### STAFF REPORT

Project: Creative Space Site Plan and Design Review

File Number: PLN50177SPR

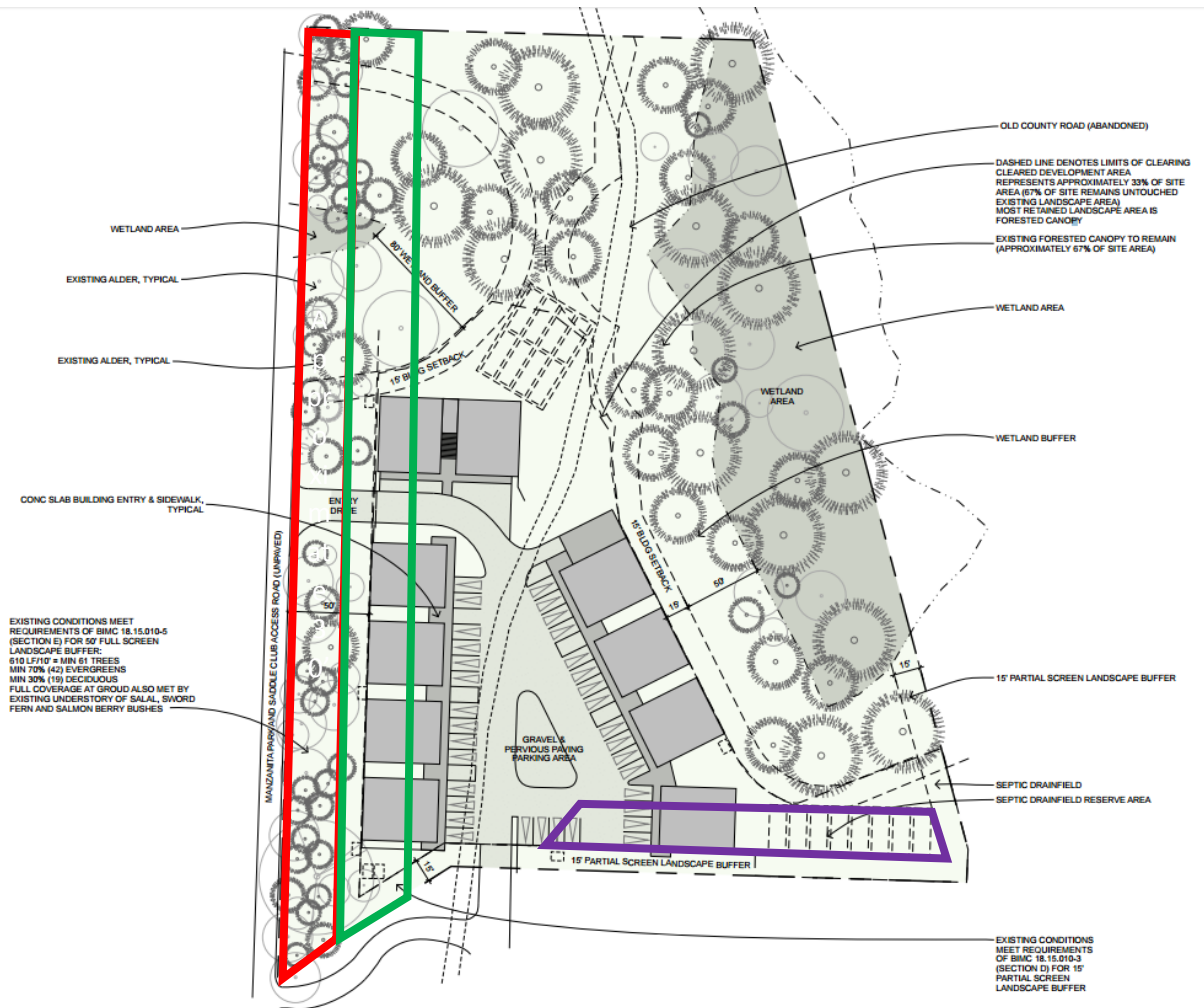
The property abuts a private road that is shared with the Saddle Club. The road is accessible from a 60' access easement, 30' of which are on the subject property. Five of the western most buildings are proposed within the 50' perimeter landscape buffer. A second 50' access and utility

easement exists on the southern border of the property, running east/west. The applicant is proposing to include within that easement area one of the buildings, a landscaping buffer, parking, and drainfields. This easement wasn't included in the applicant's proposed site plans. In researching the site, the City discovered the easement and informed the applicant about the existence of the easement. When so informed by the City, the applicant responded by indicating that they would vacate the easement, without specifying how this would be accomplished (reference doc 19).

□ Approximate 30' easement    
 □ Approximate 50' landscape buffer    
 □ Approximate 50' easement
